CL4.56 MODIFICATION

"THE ORCHARD"
CHILDCARE CENTRE
723-727 WARRINGAH ROAD
FORESTVILLE

SITE PLAN	Drawn By: DM	Checked: CB	Project No: 3318	
	Date:		Sheet No:	
	23 MARCH 2018		A0002	
	Scale:		Issue:	Revision:
	1:200)	CL4.56 MODIFICATION	G
is intended that the drawings only represent the visual design of the work and any technical details are awings or calculations for compliance with any relevant industry, safety standards or regulations. All designs on the compliance of the compl	imensions are to I	oe checked on site	and any discrepancies are to be re	ferred to Liquid Design Pty

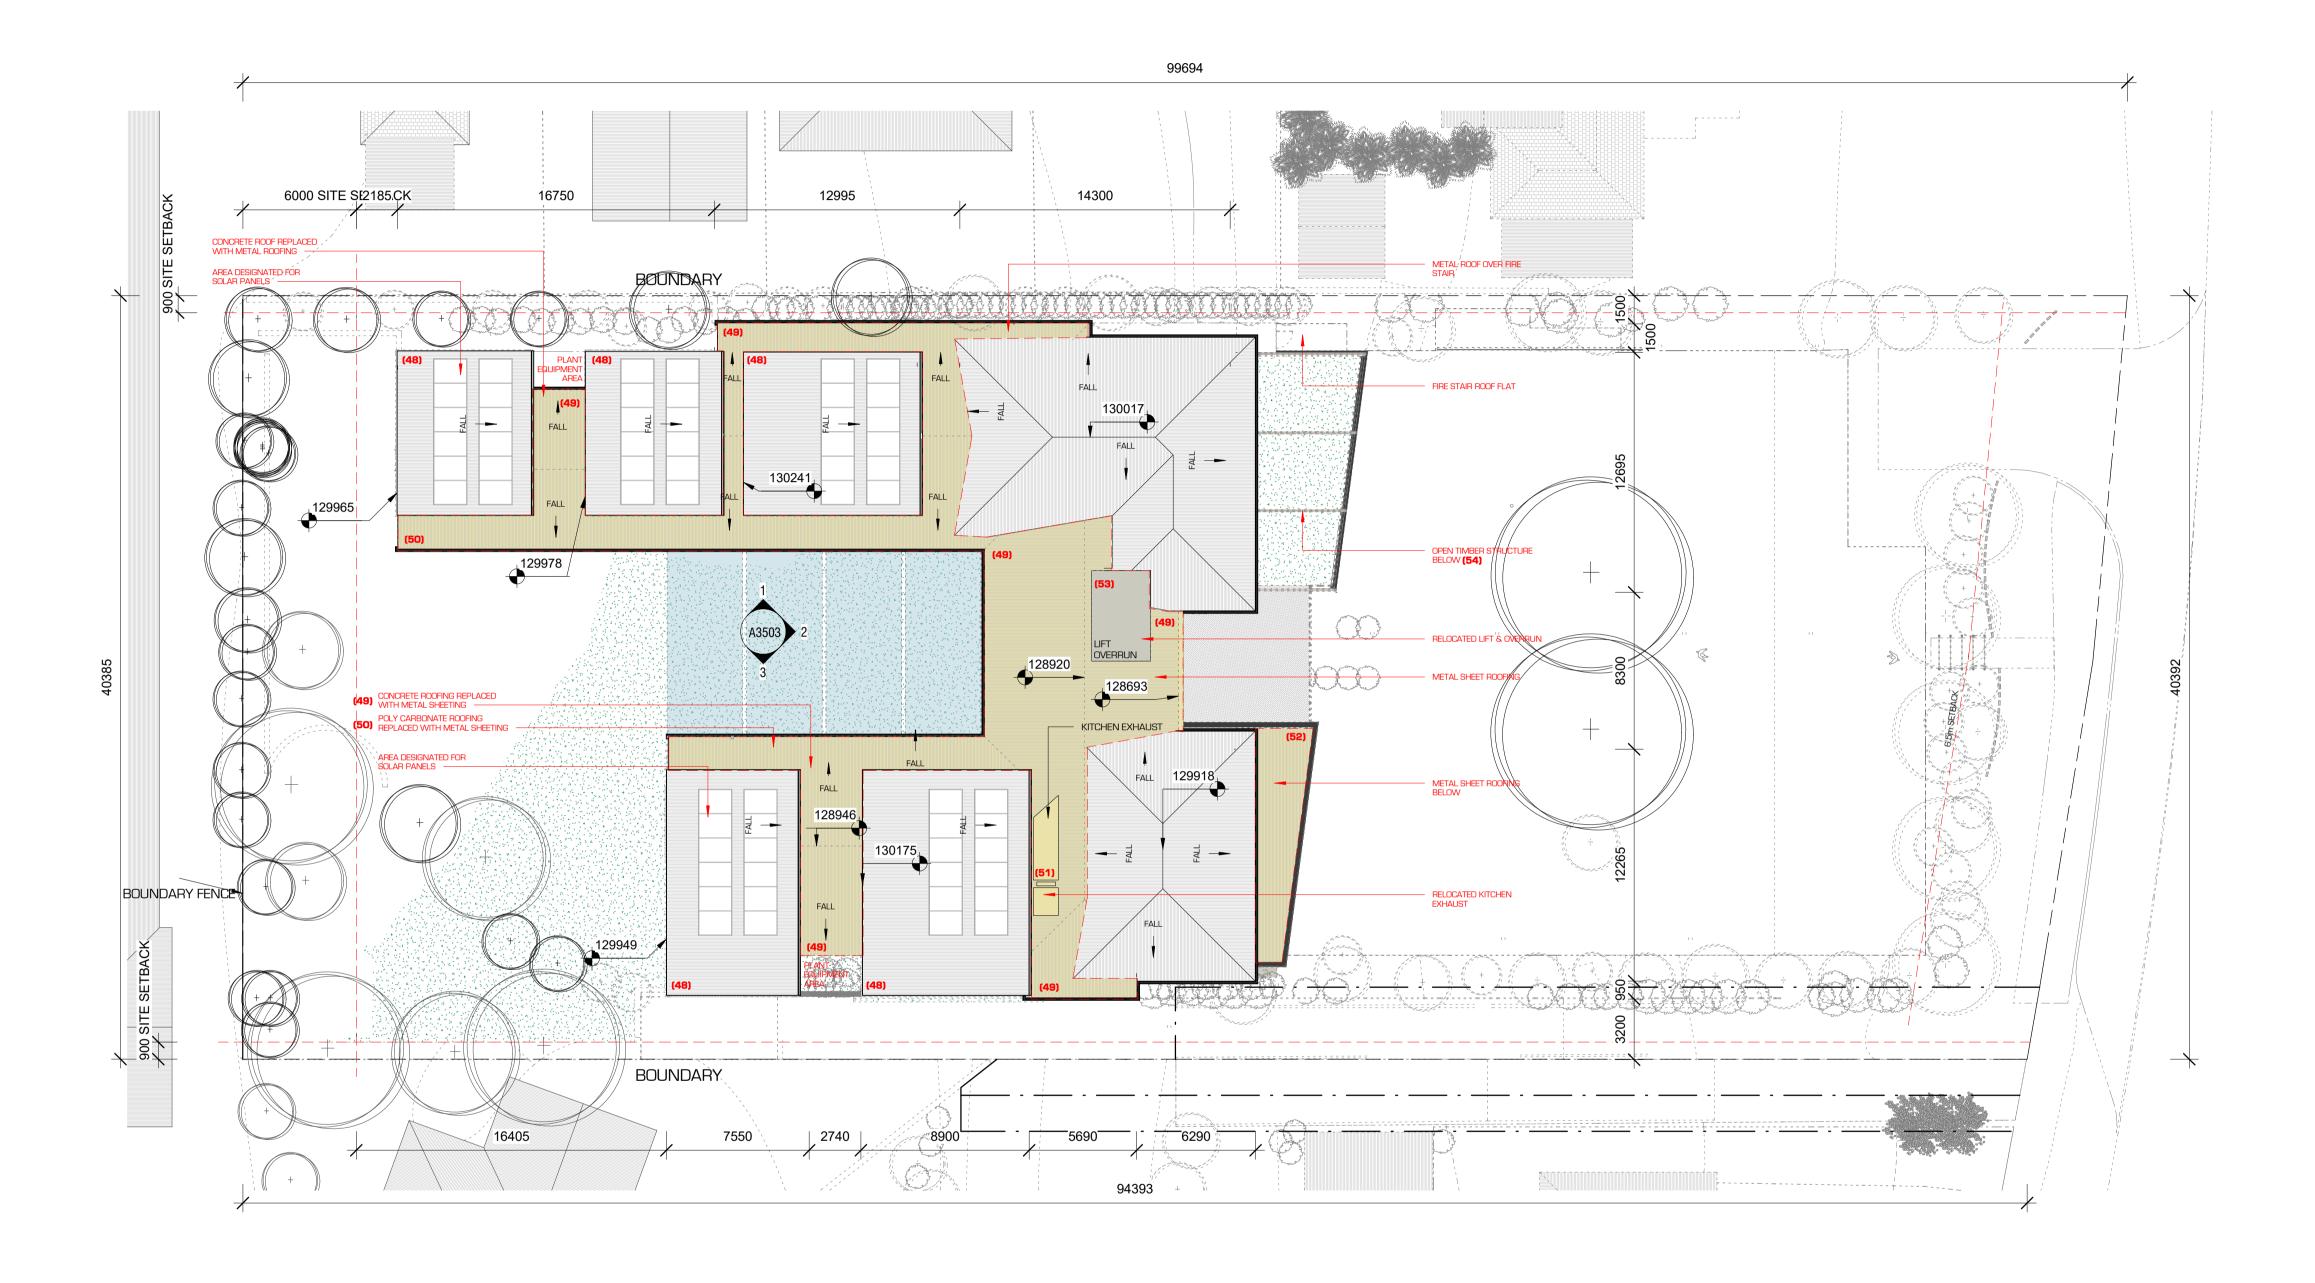
EXTERNAL ENVELOPE OF THE PROPOSED BUILDING REMAINS

UNCHANGED
THE EXTENT OF EXCAVATION HAS BEEN AMENDED COVER WAS
REMOVED TO THE EXTENT POSSIBLE OVER THE THE LEVEL 1 OUTDOOR SPACE AND THE WESTERLY GLAZED WALL IS PROPOSED AS A BASLUSTRADE.
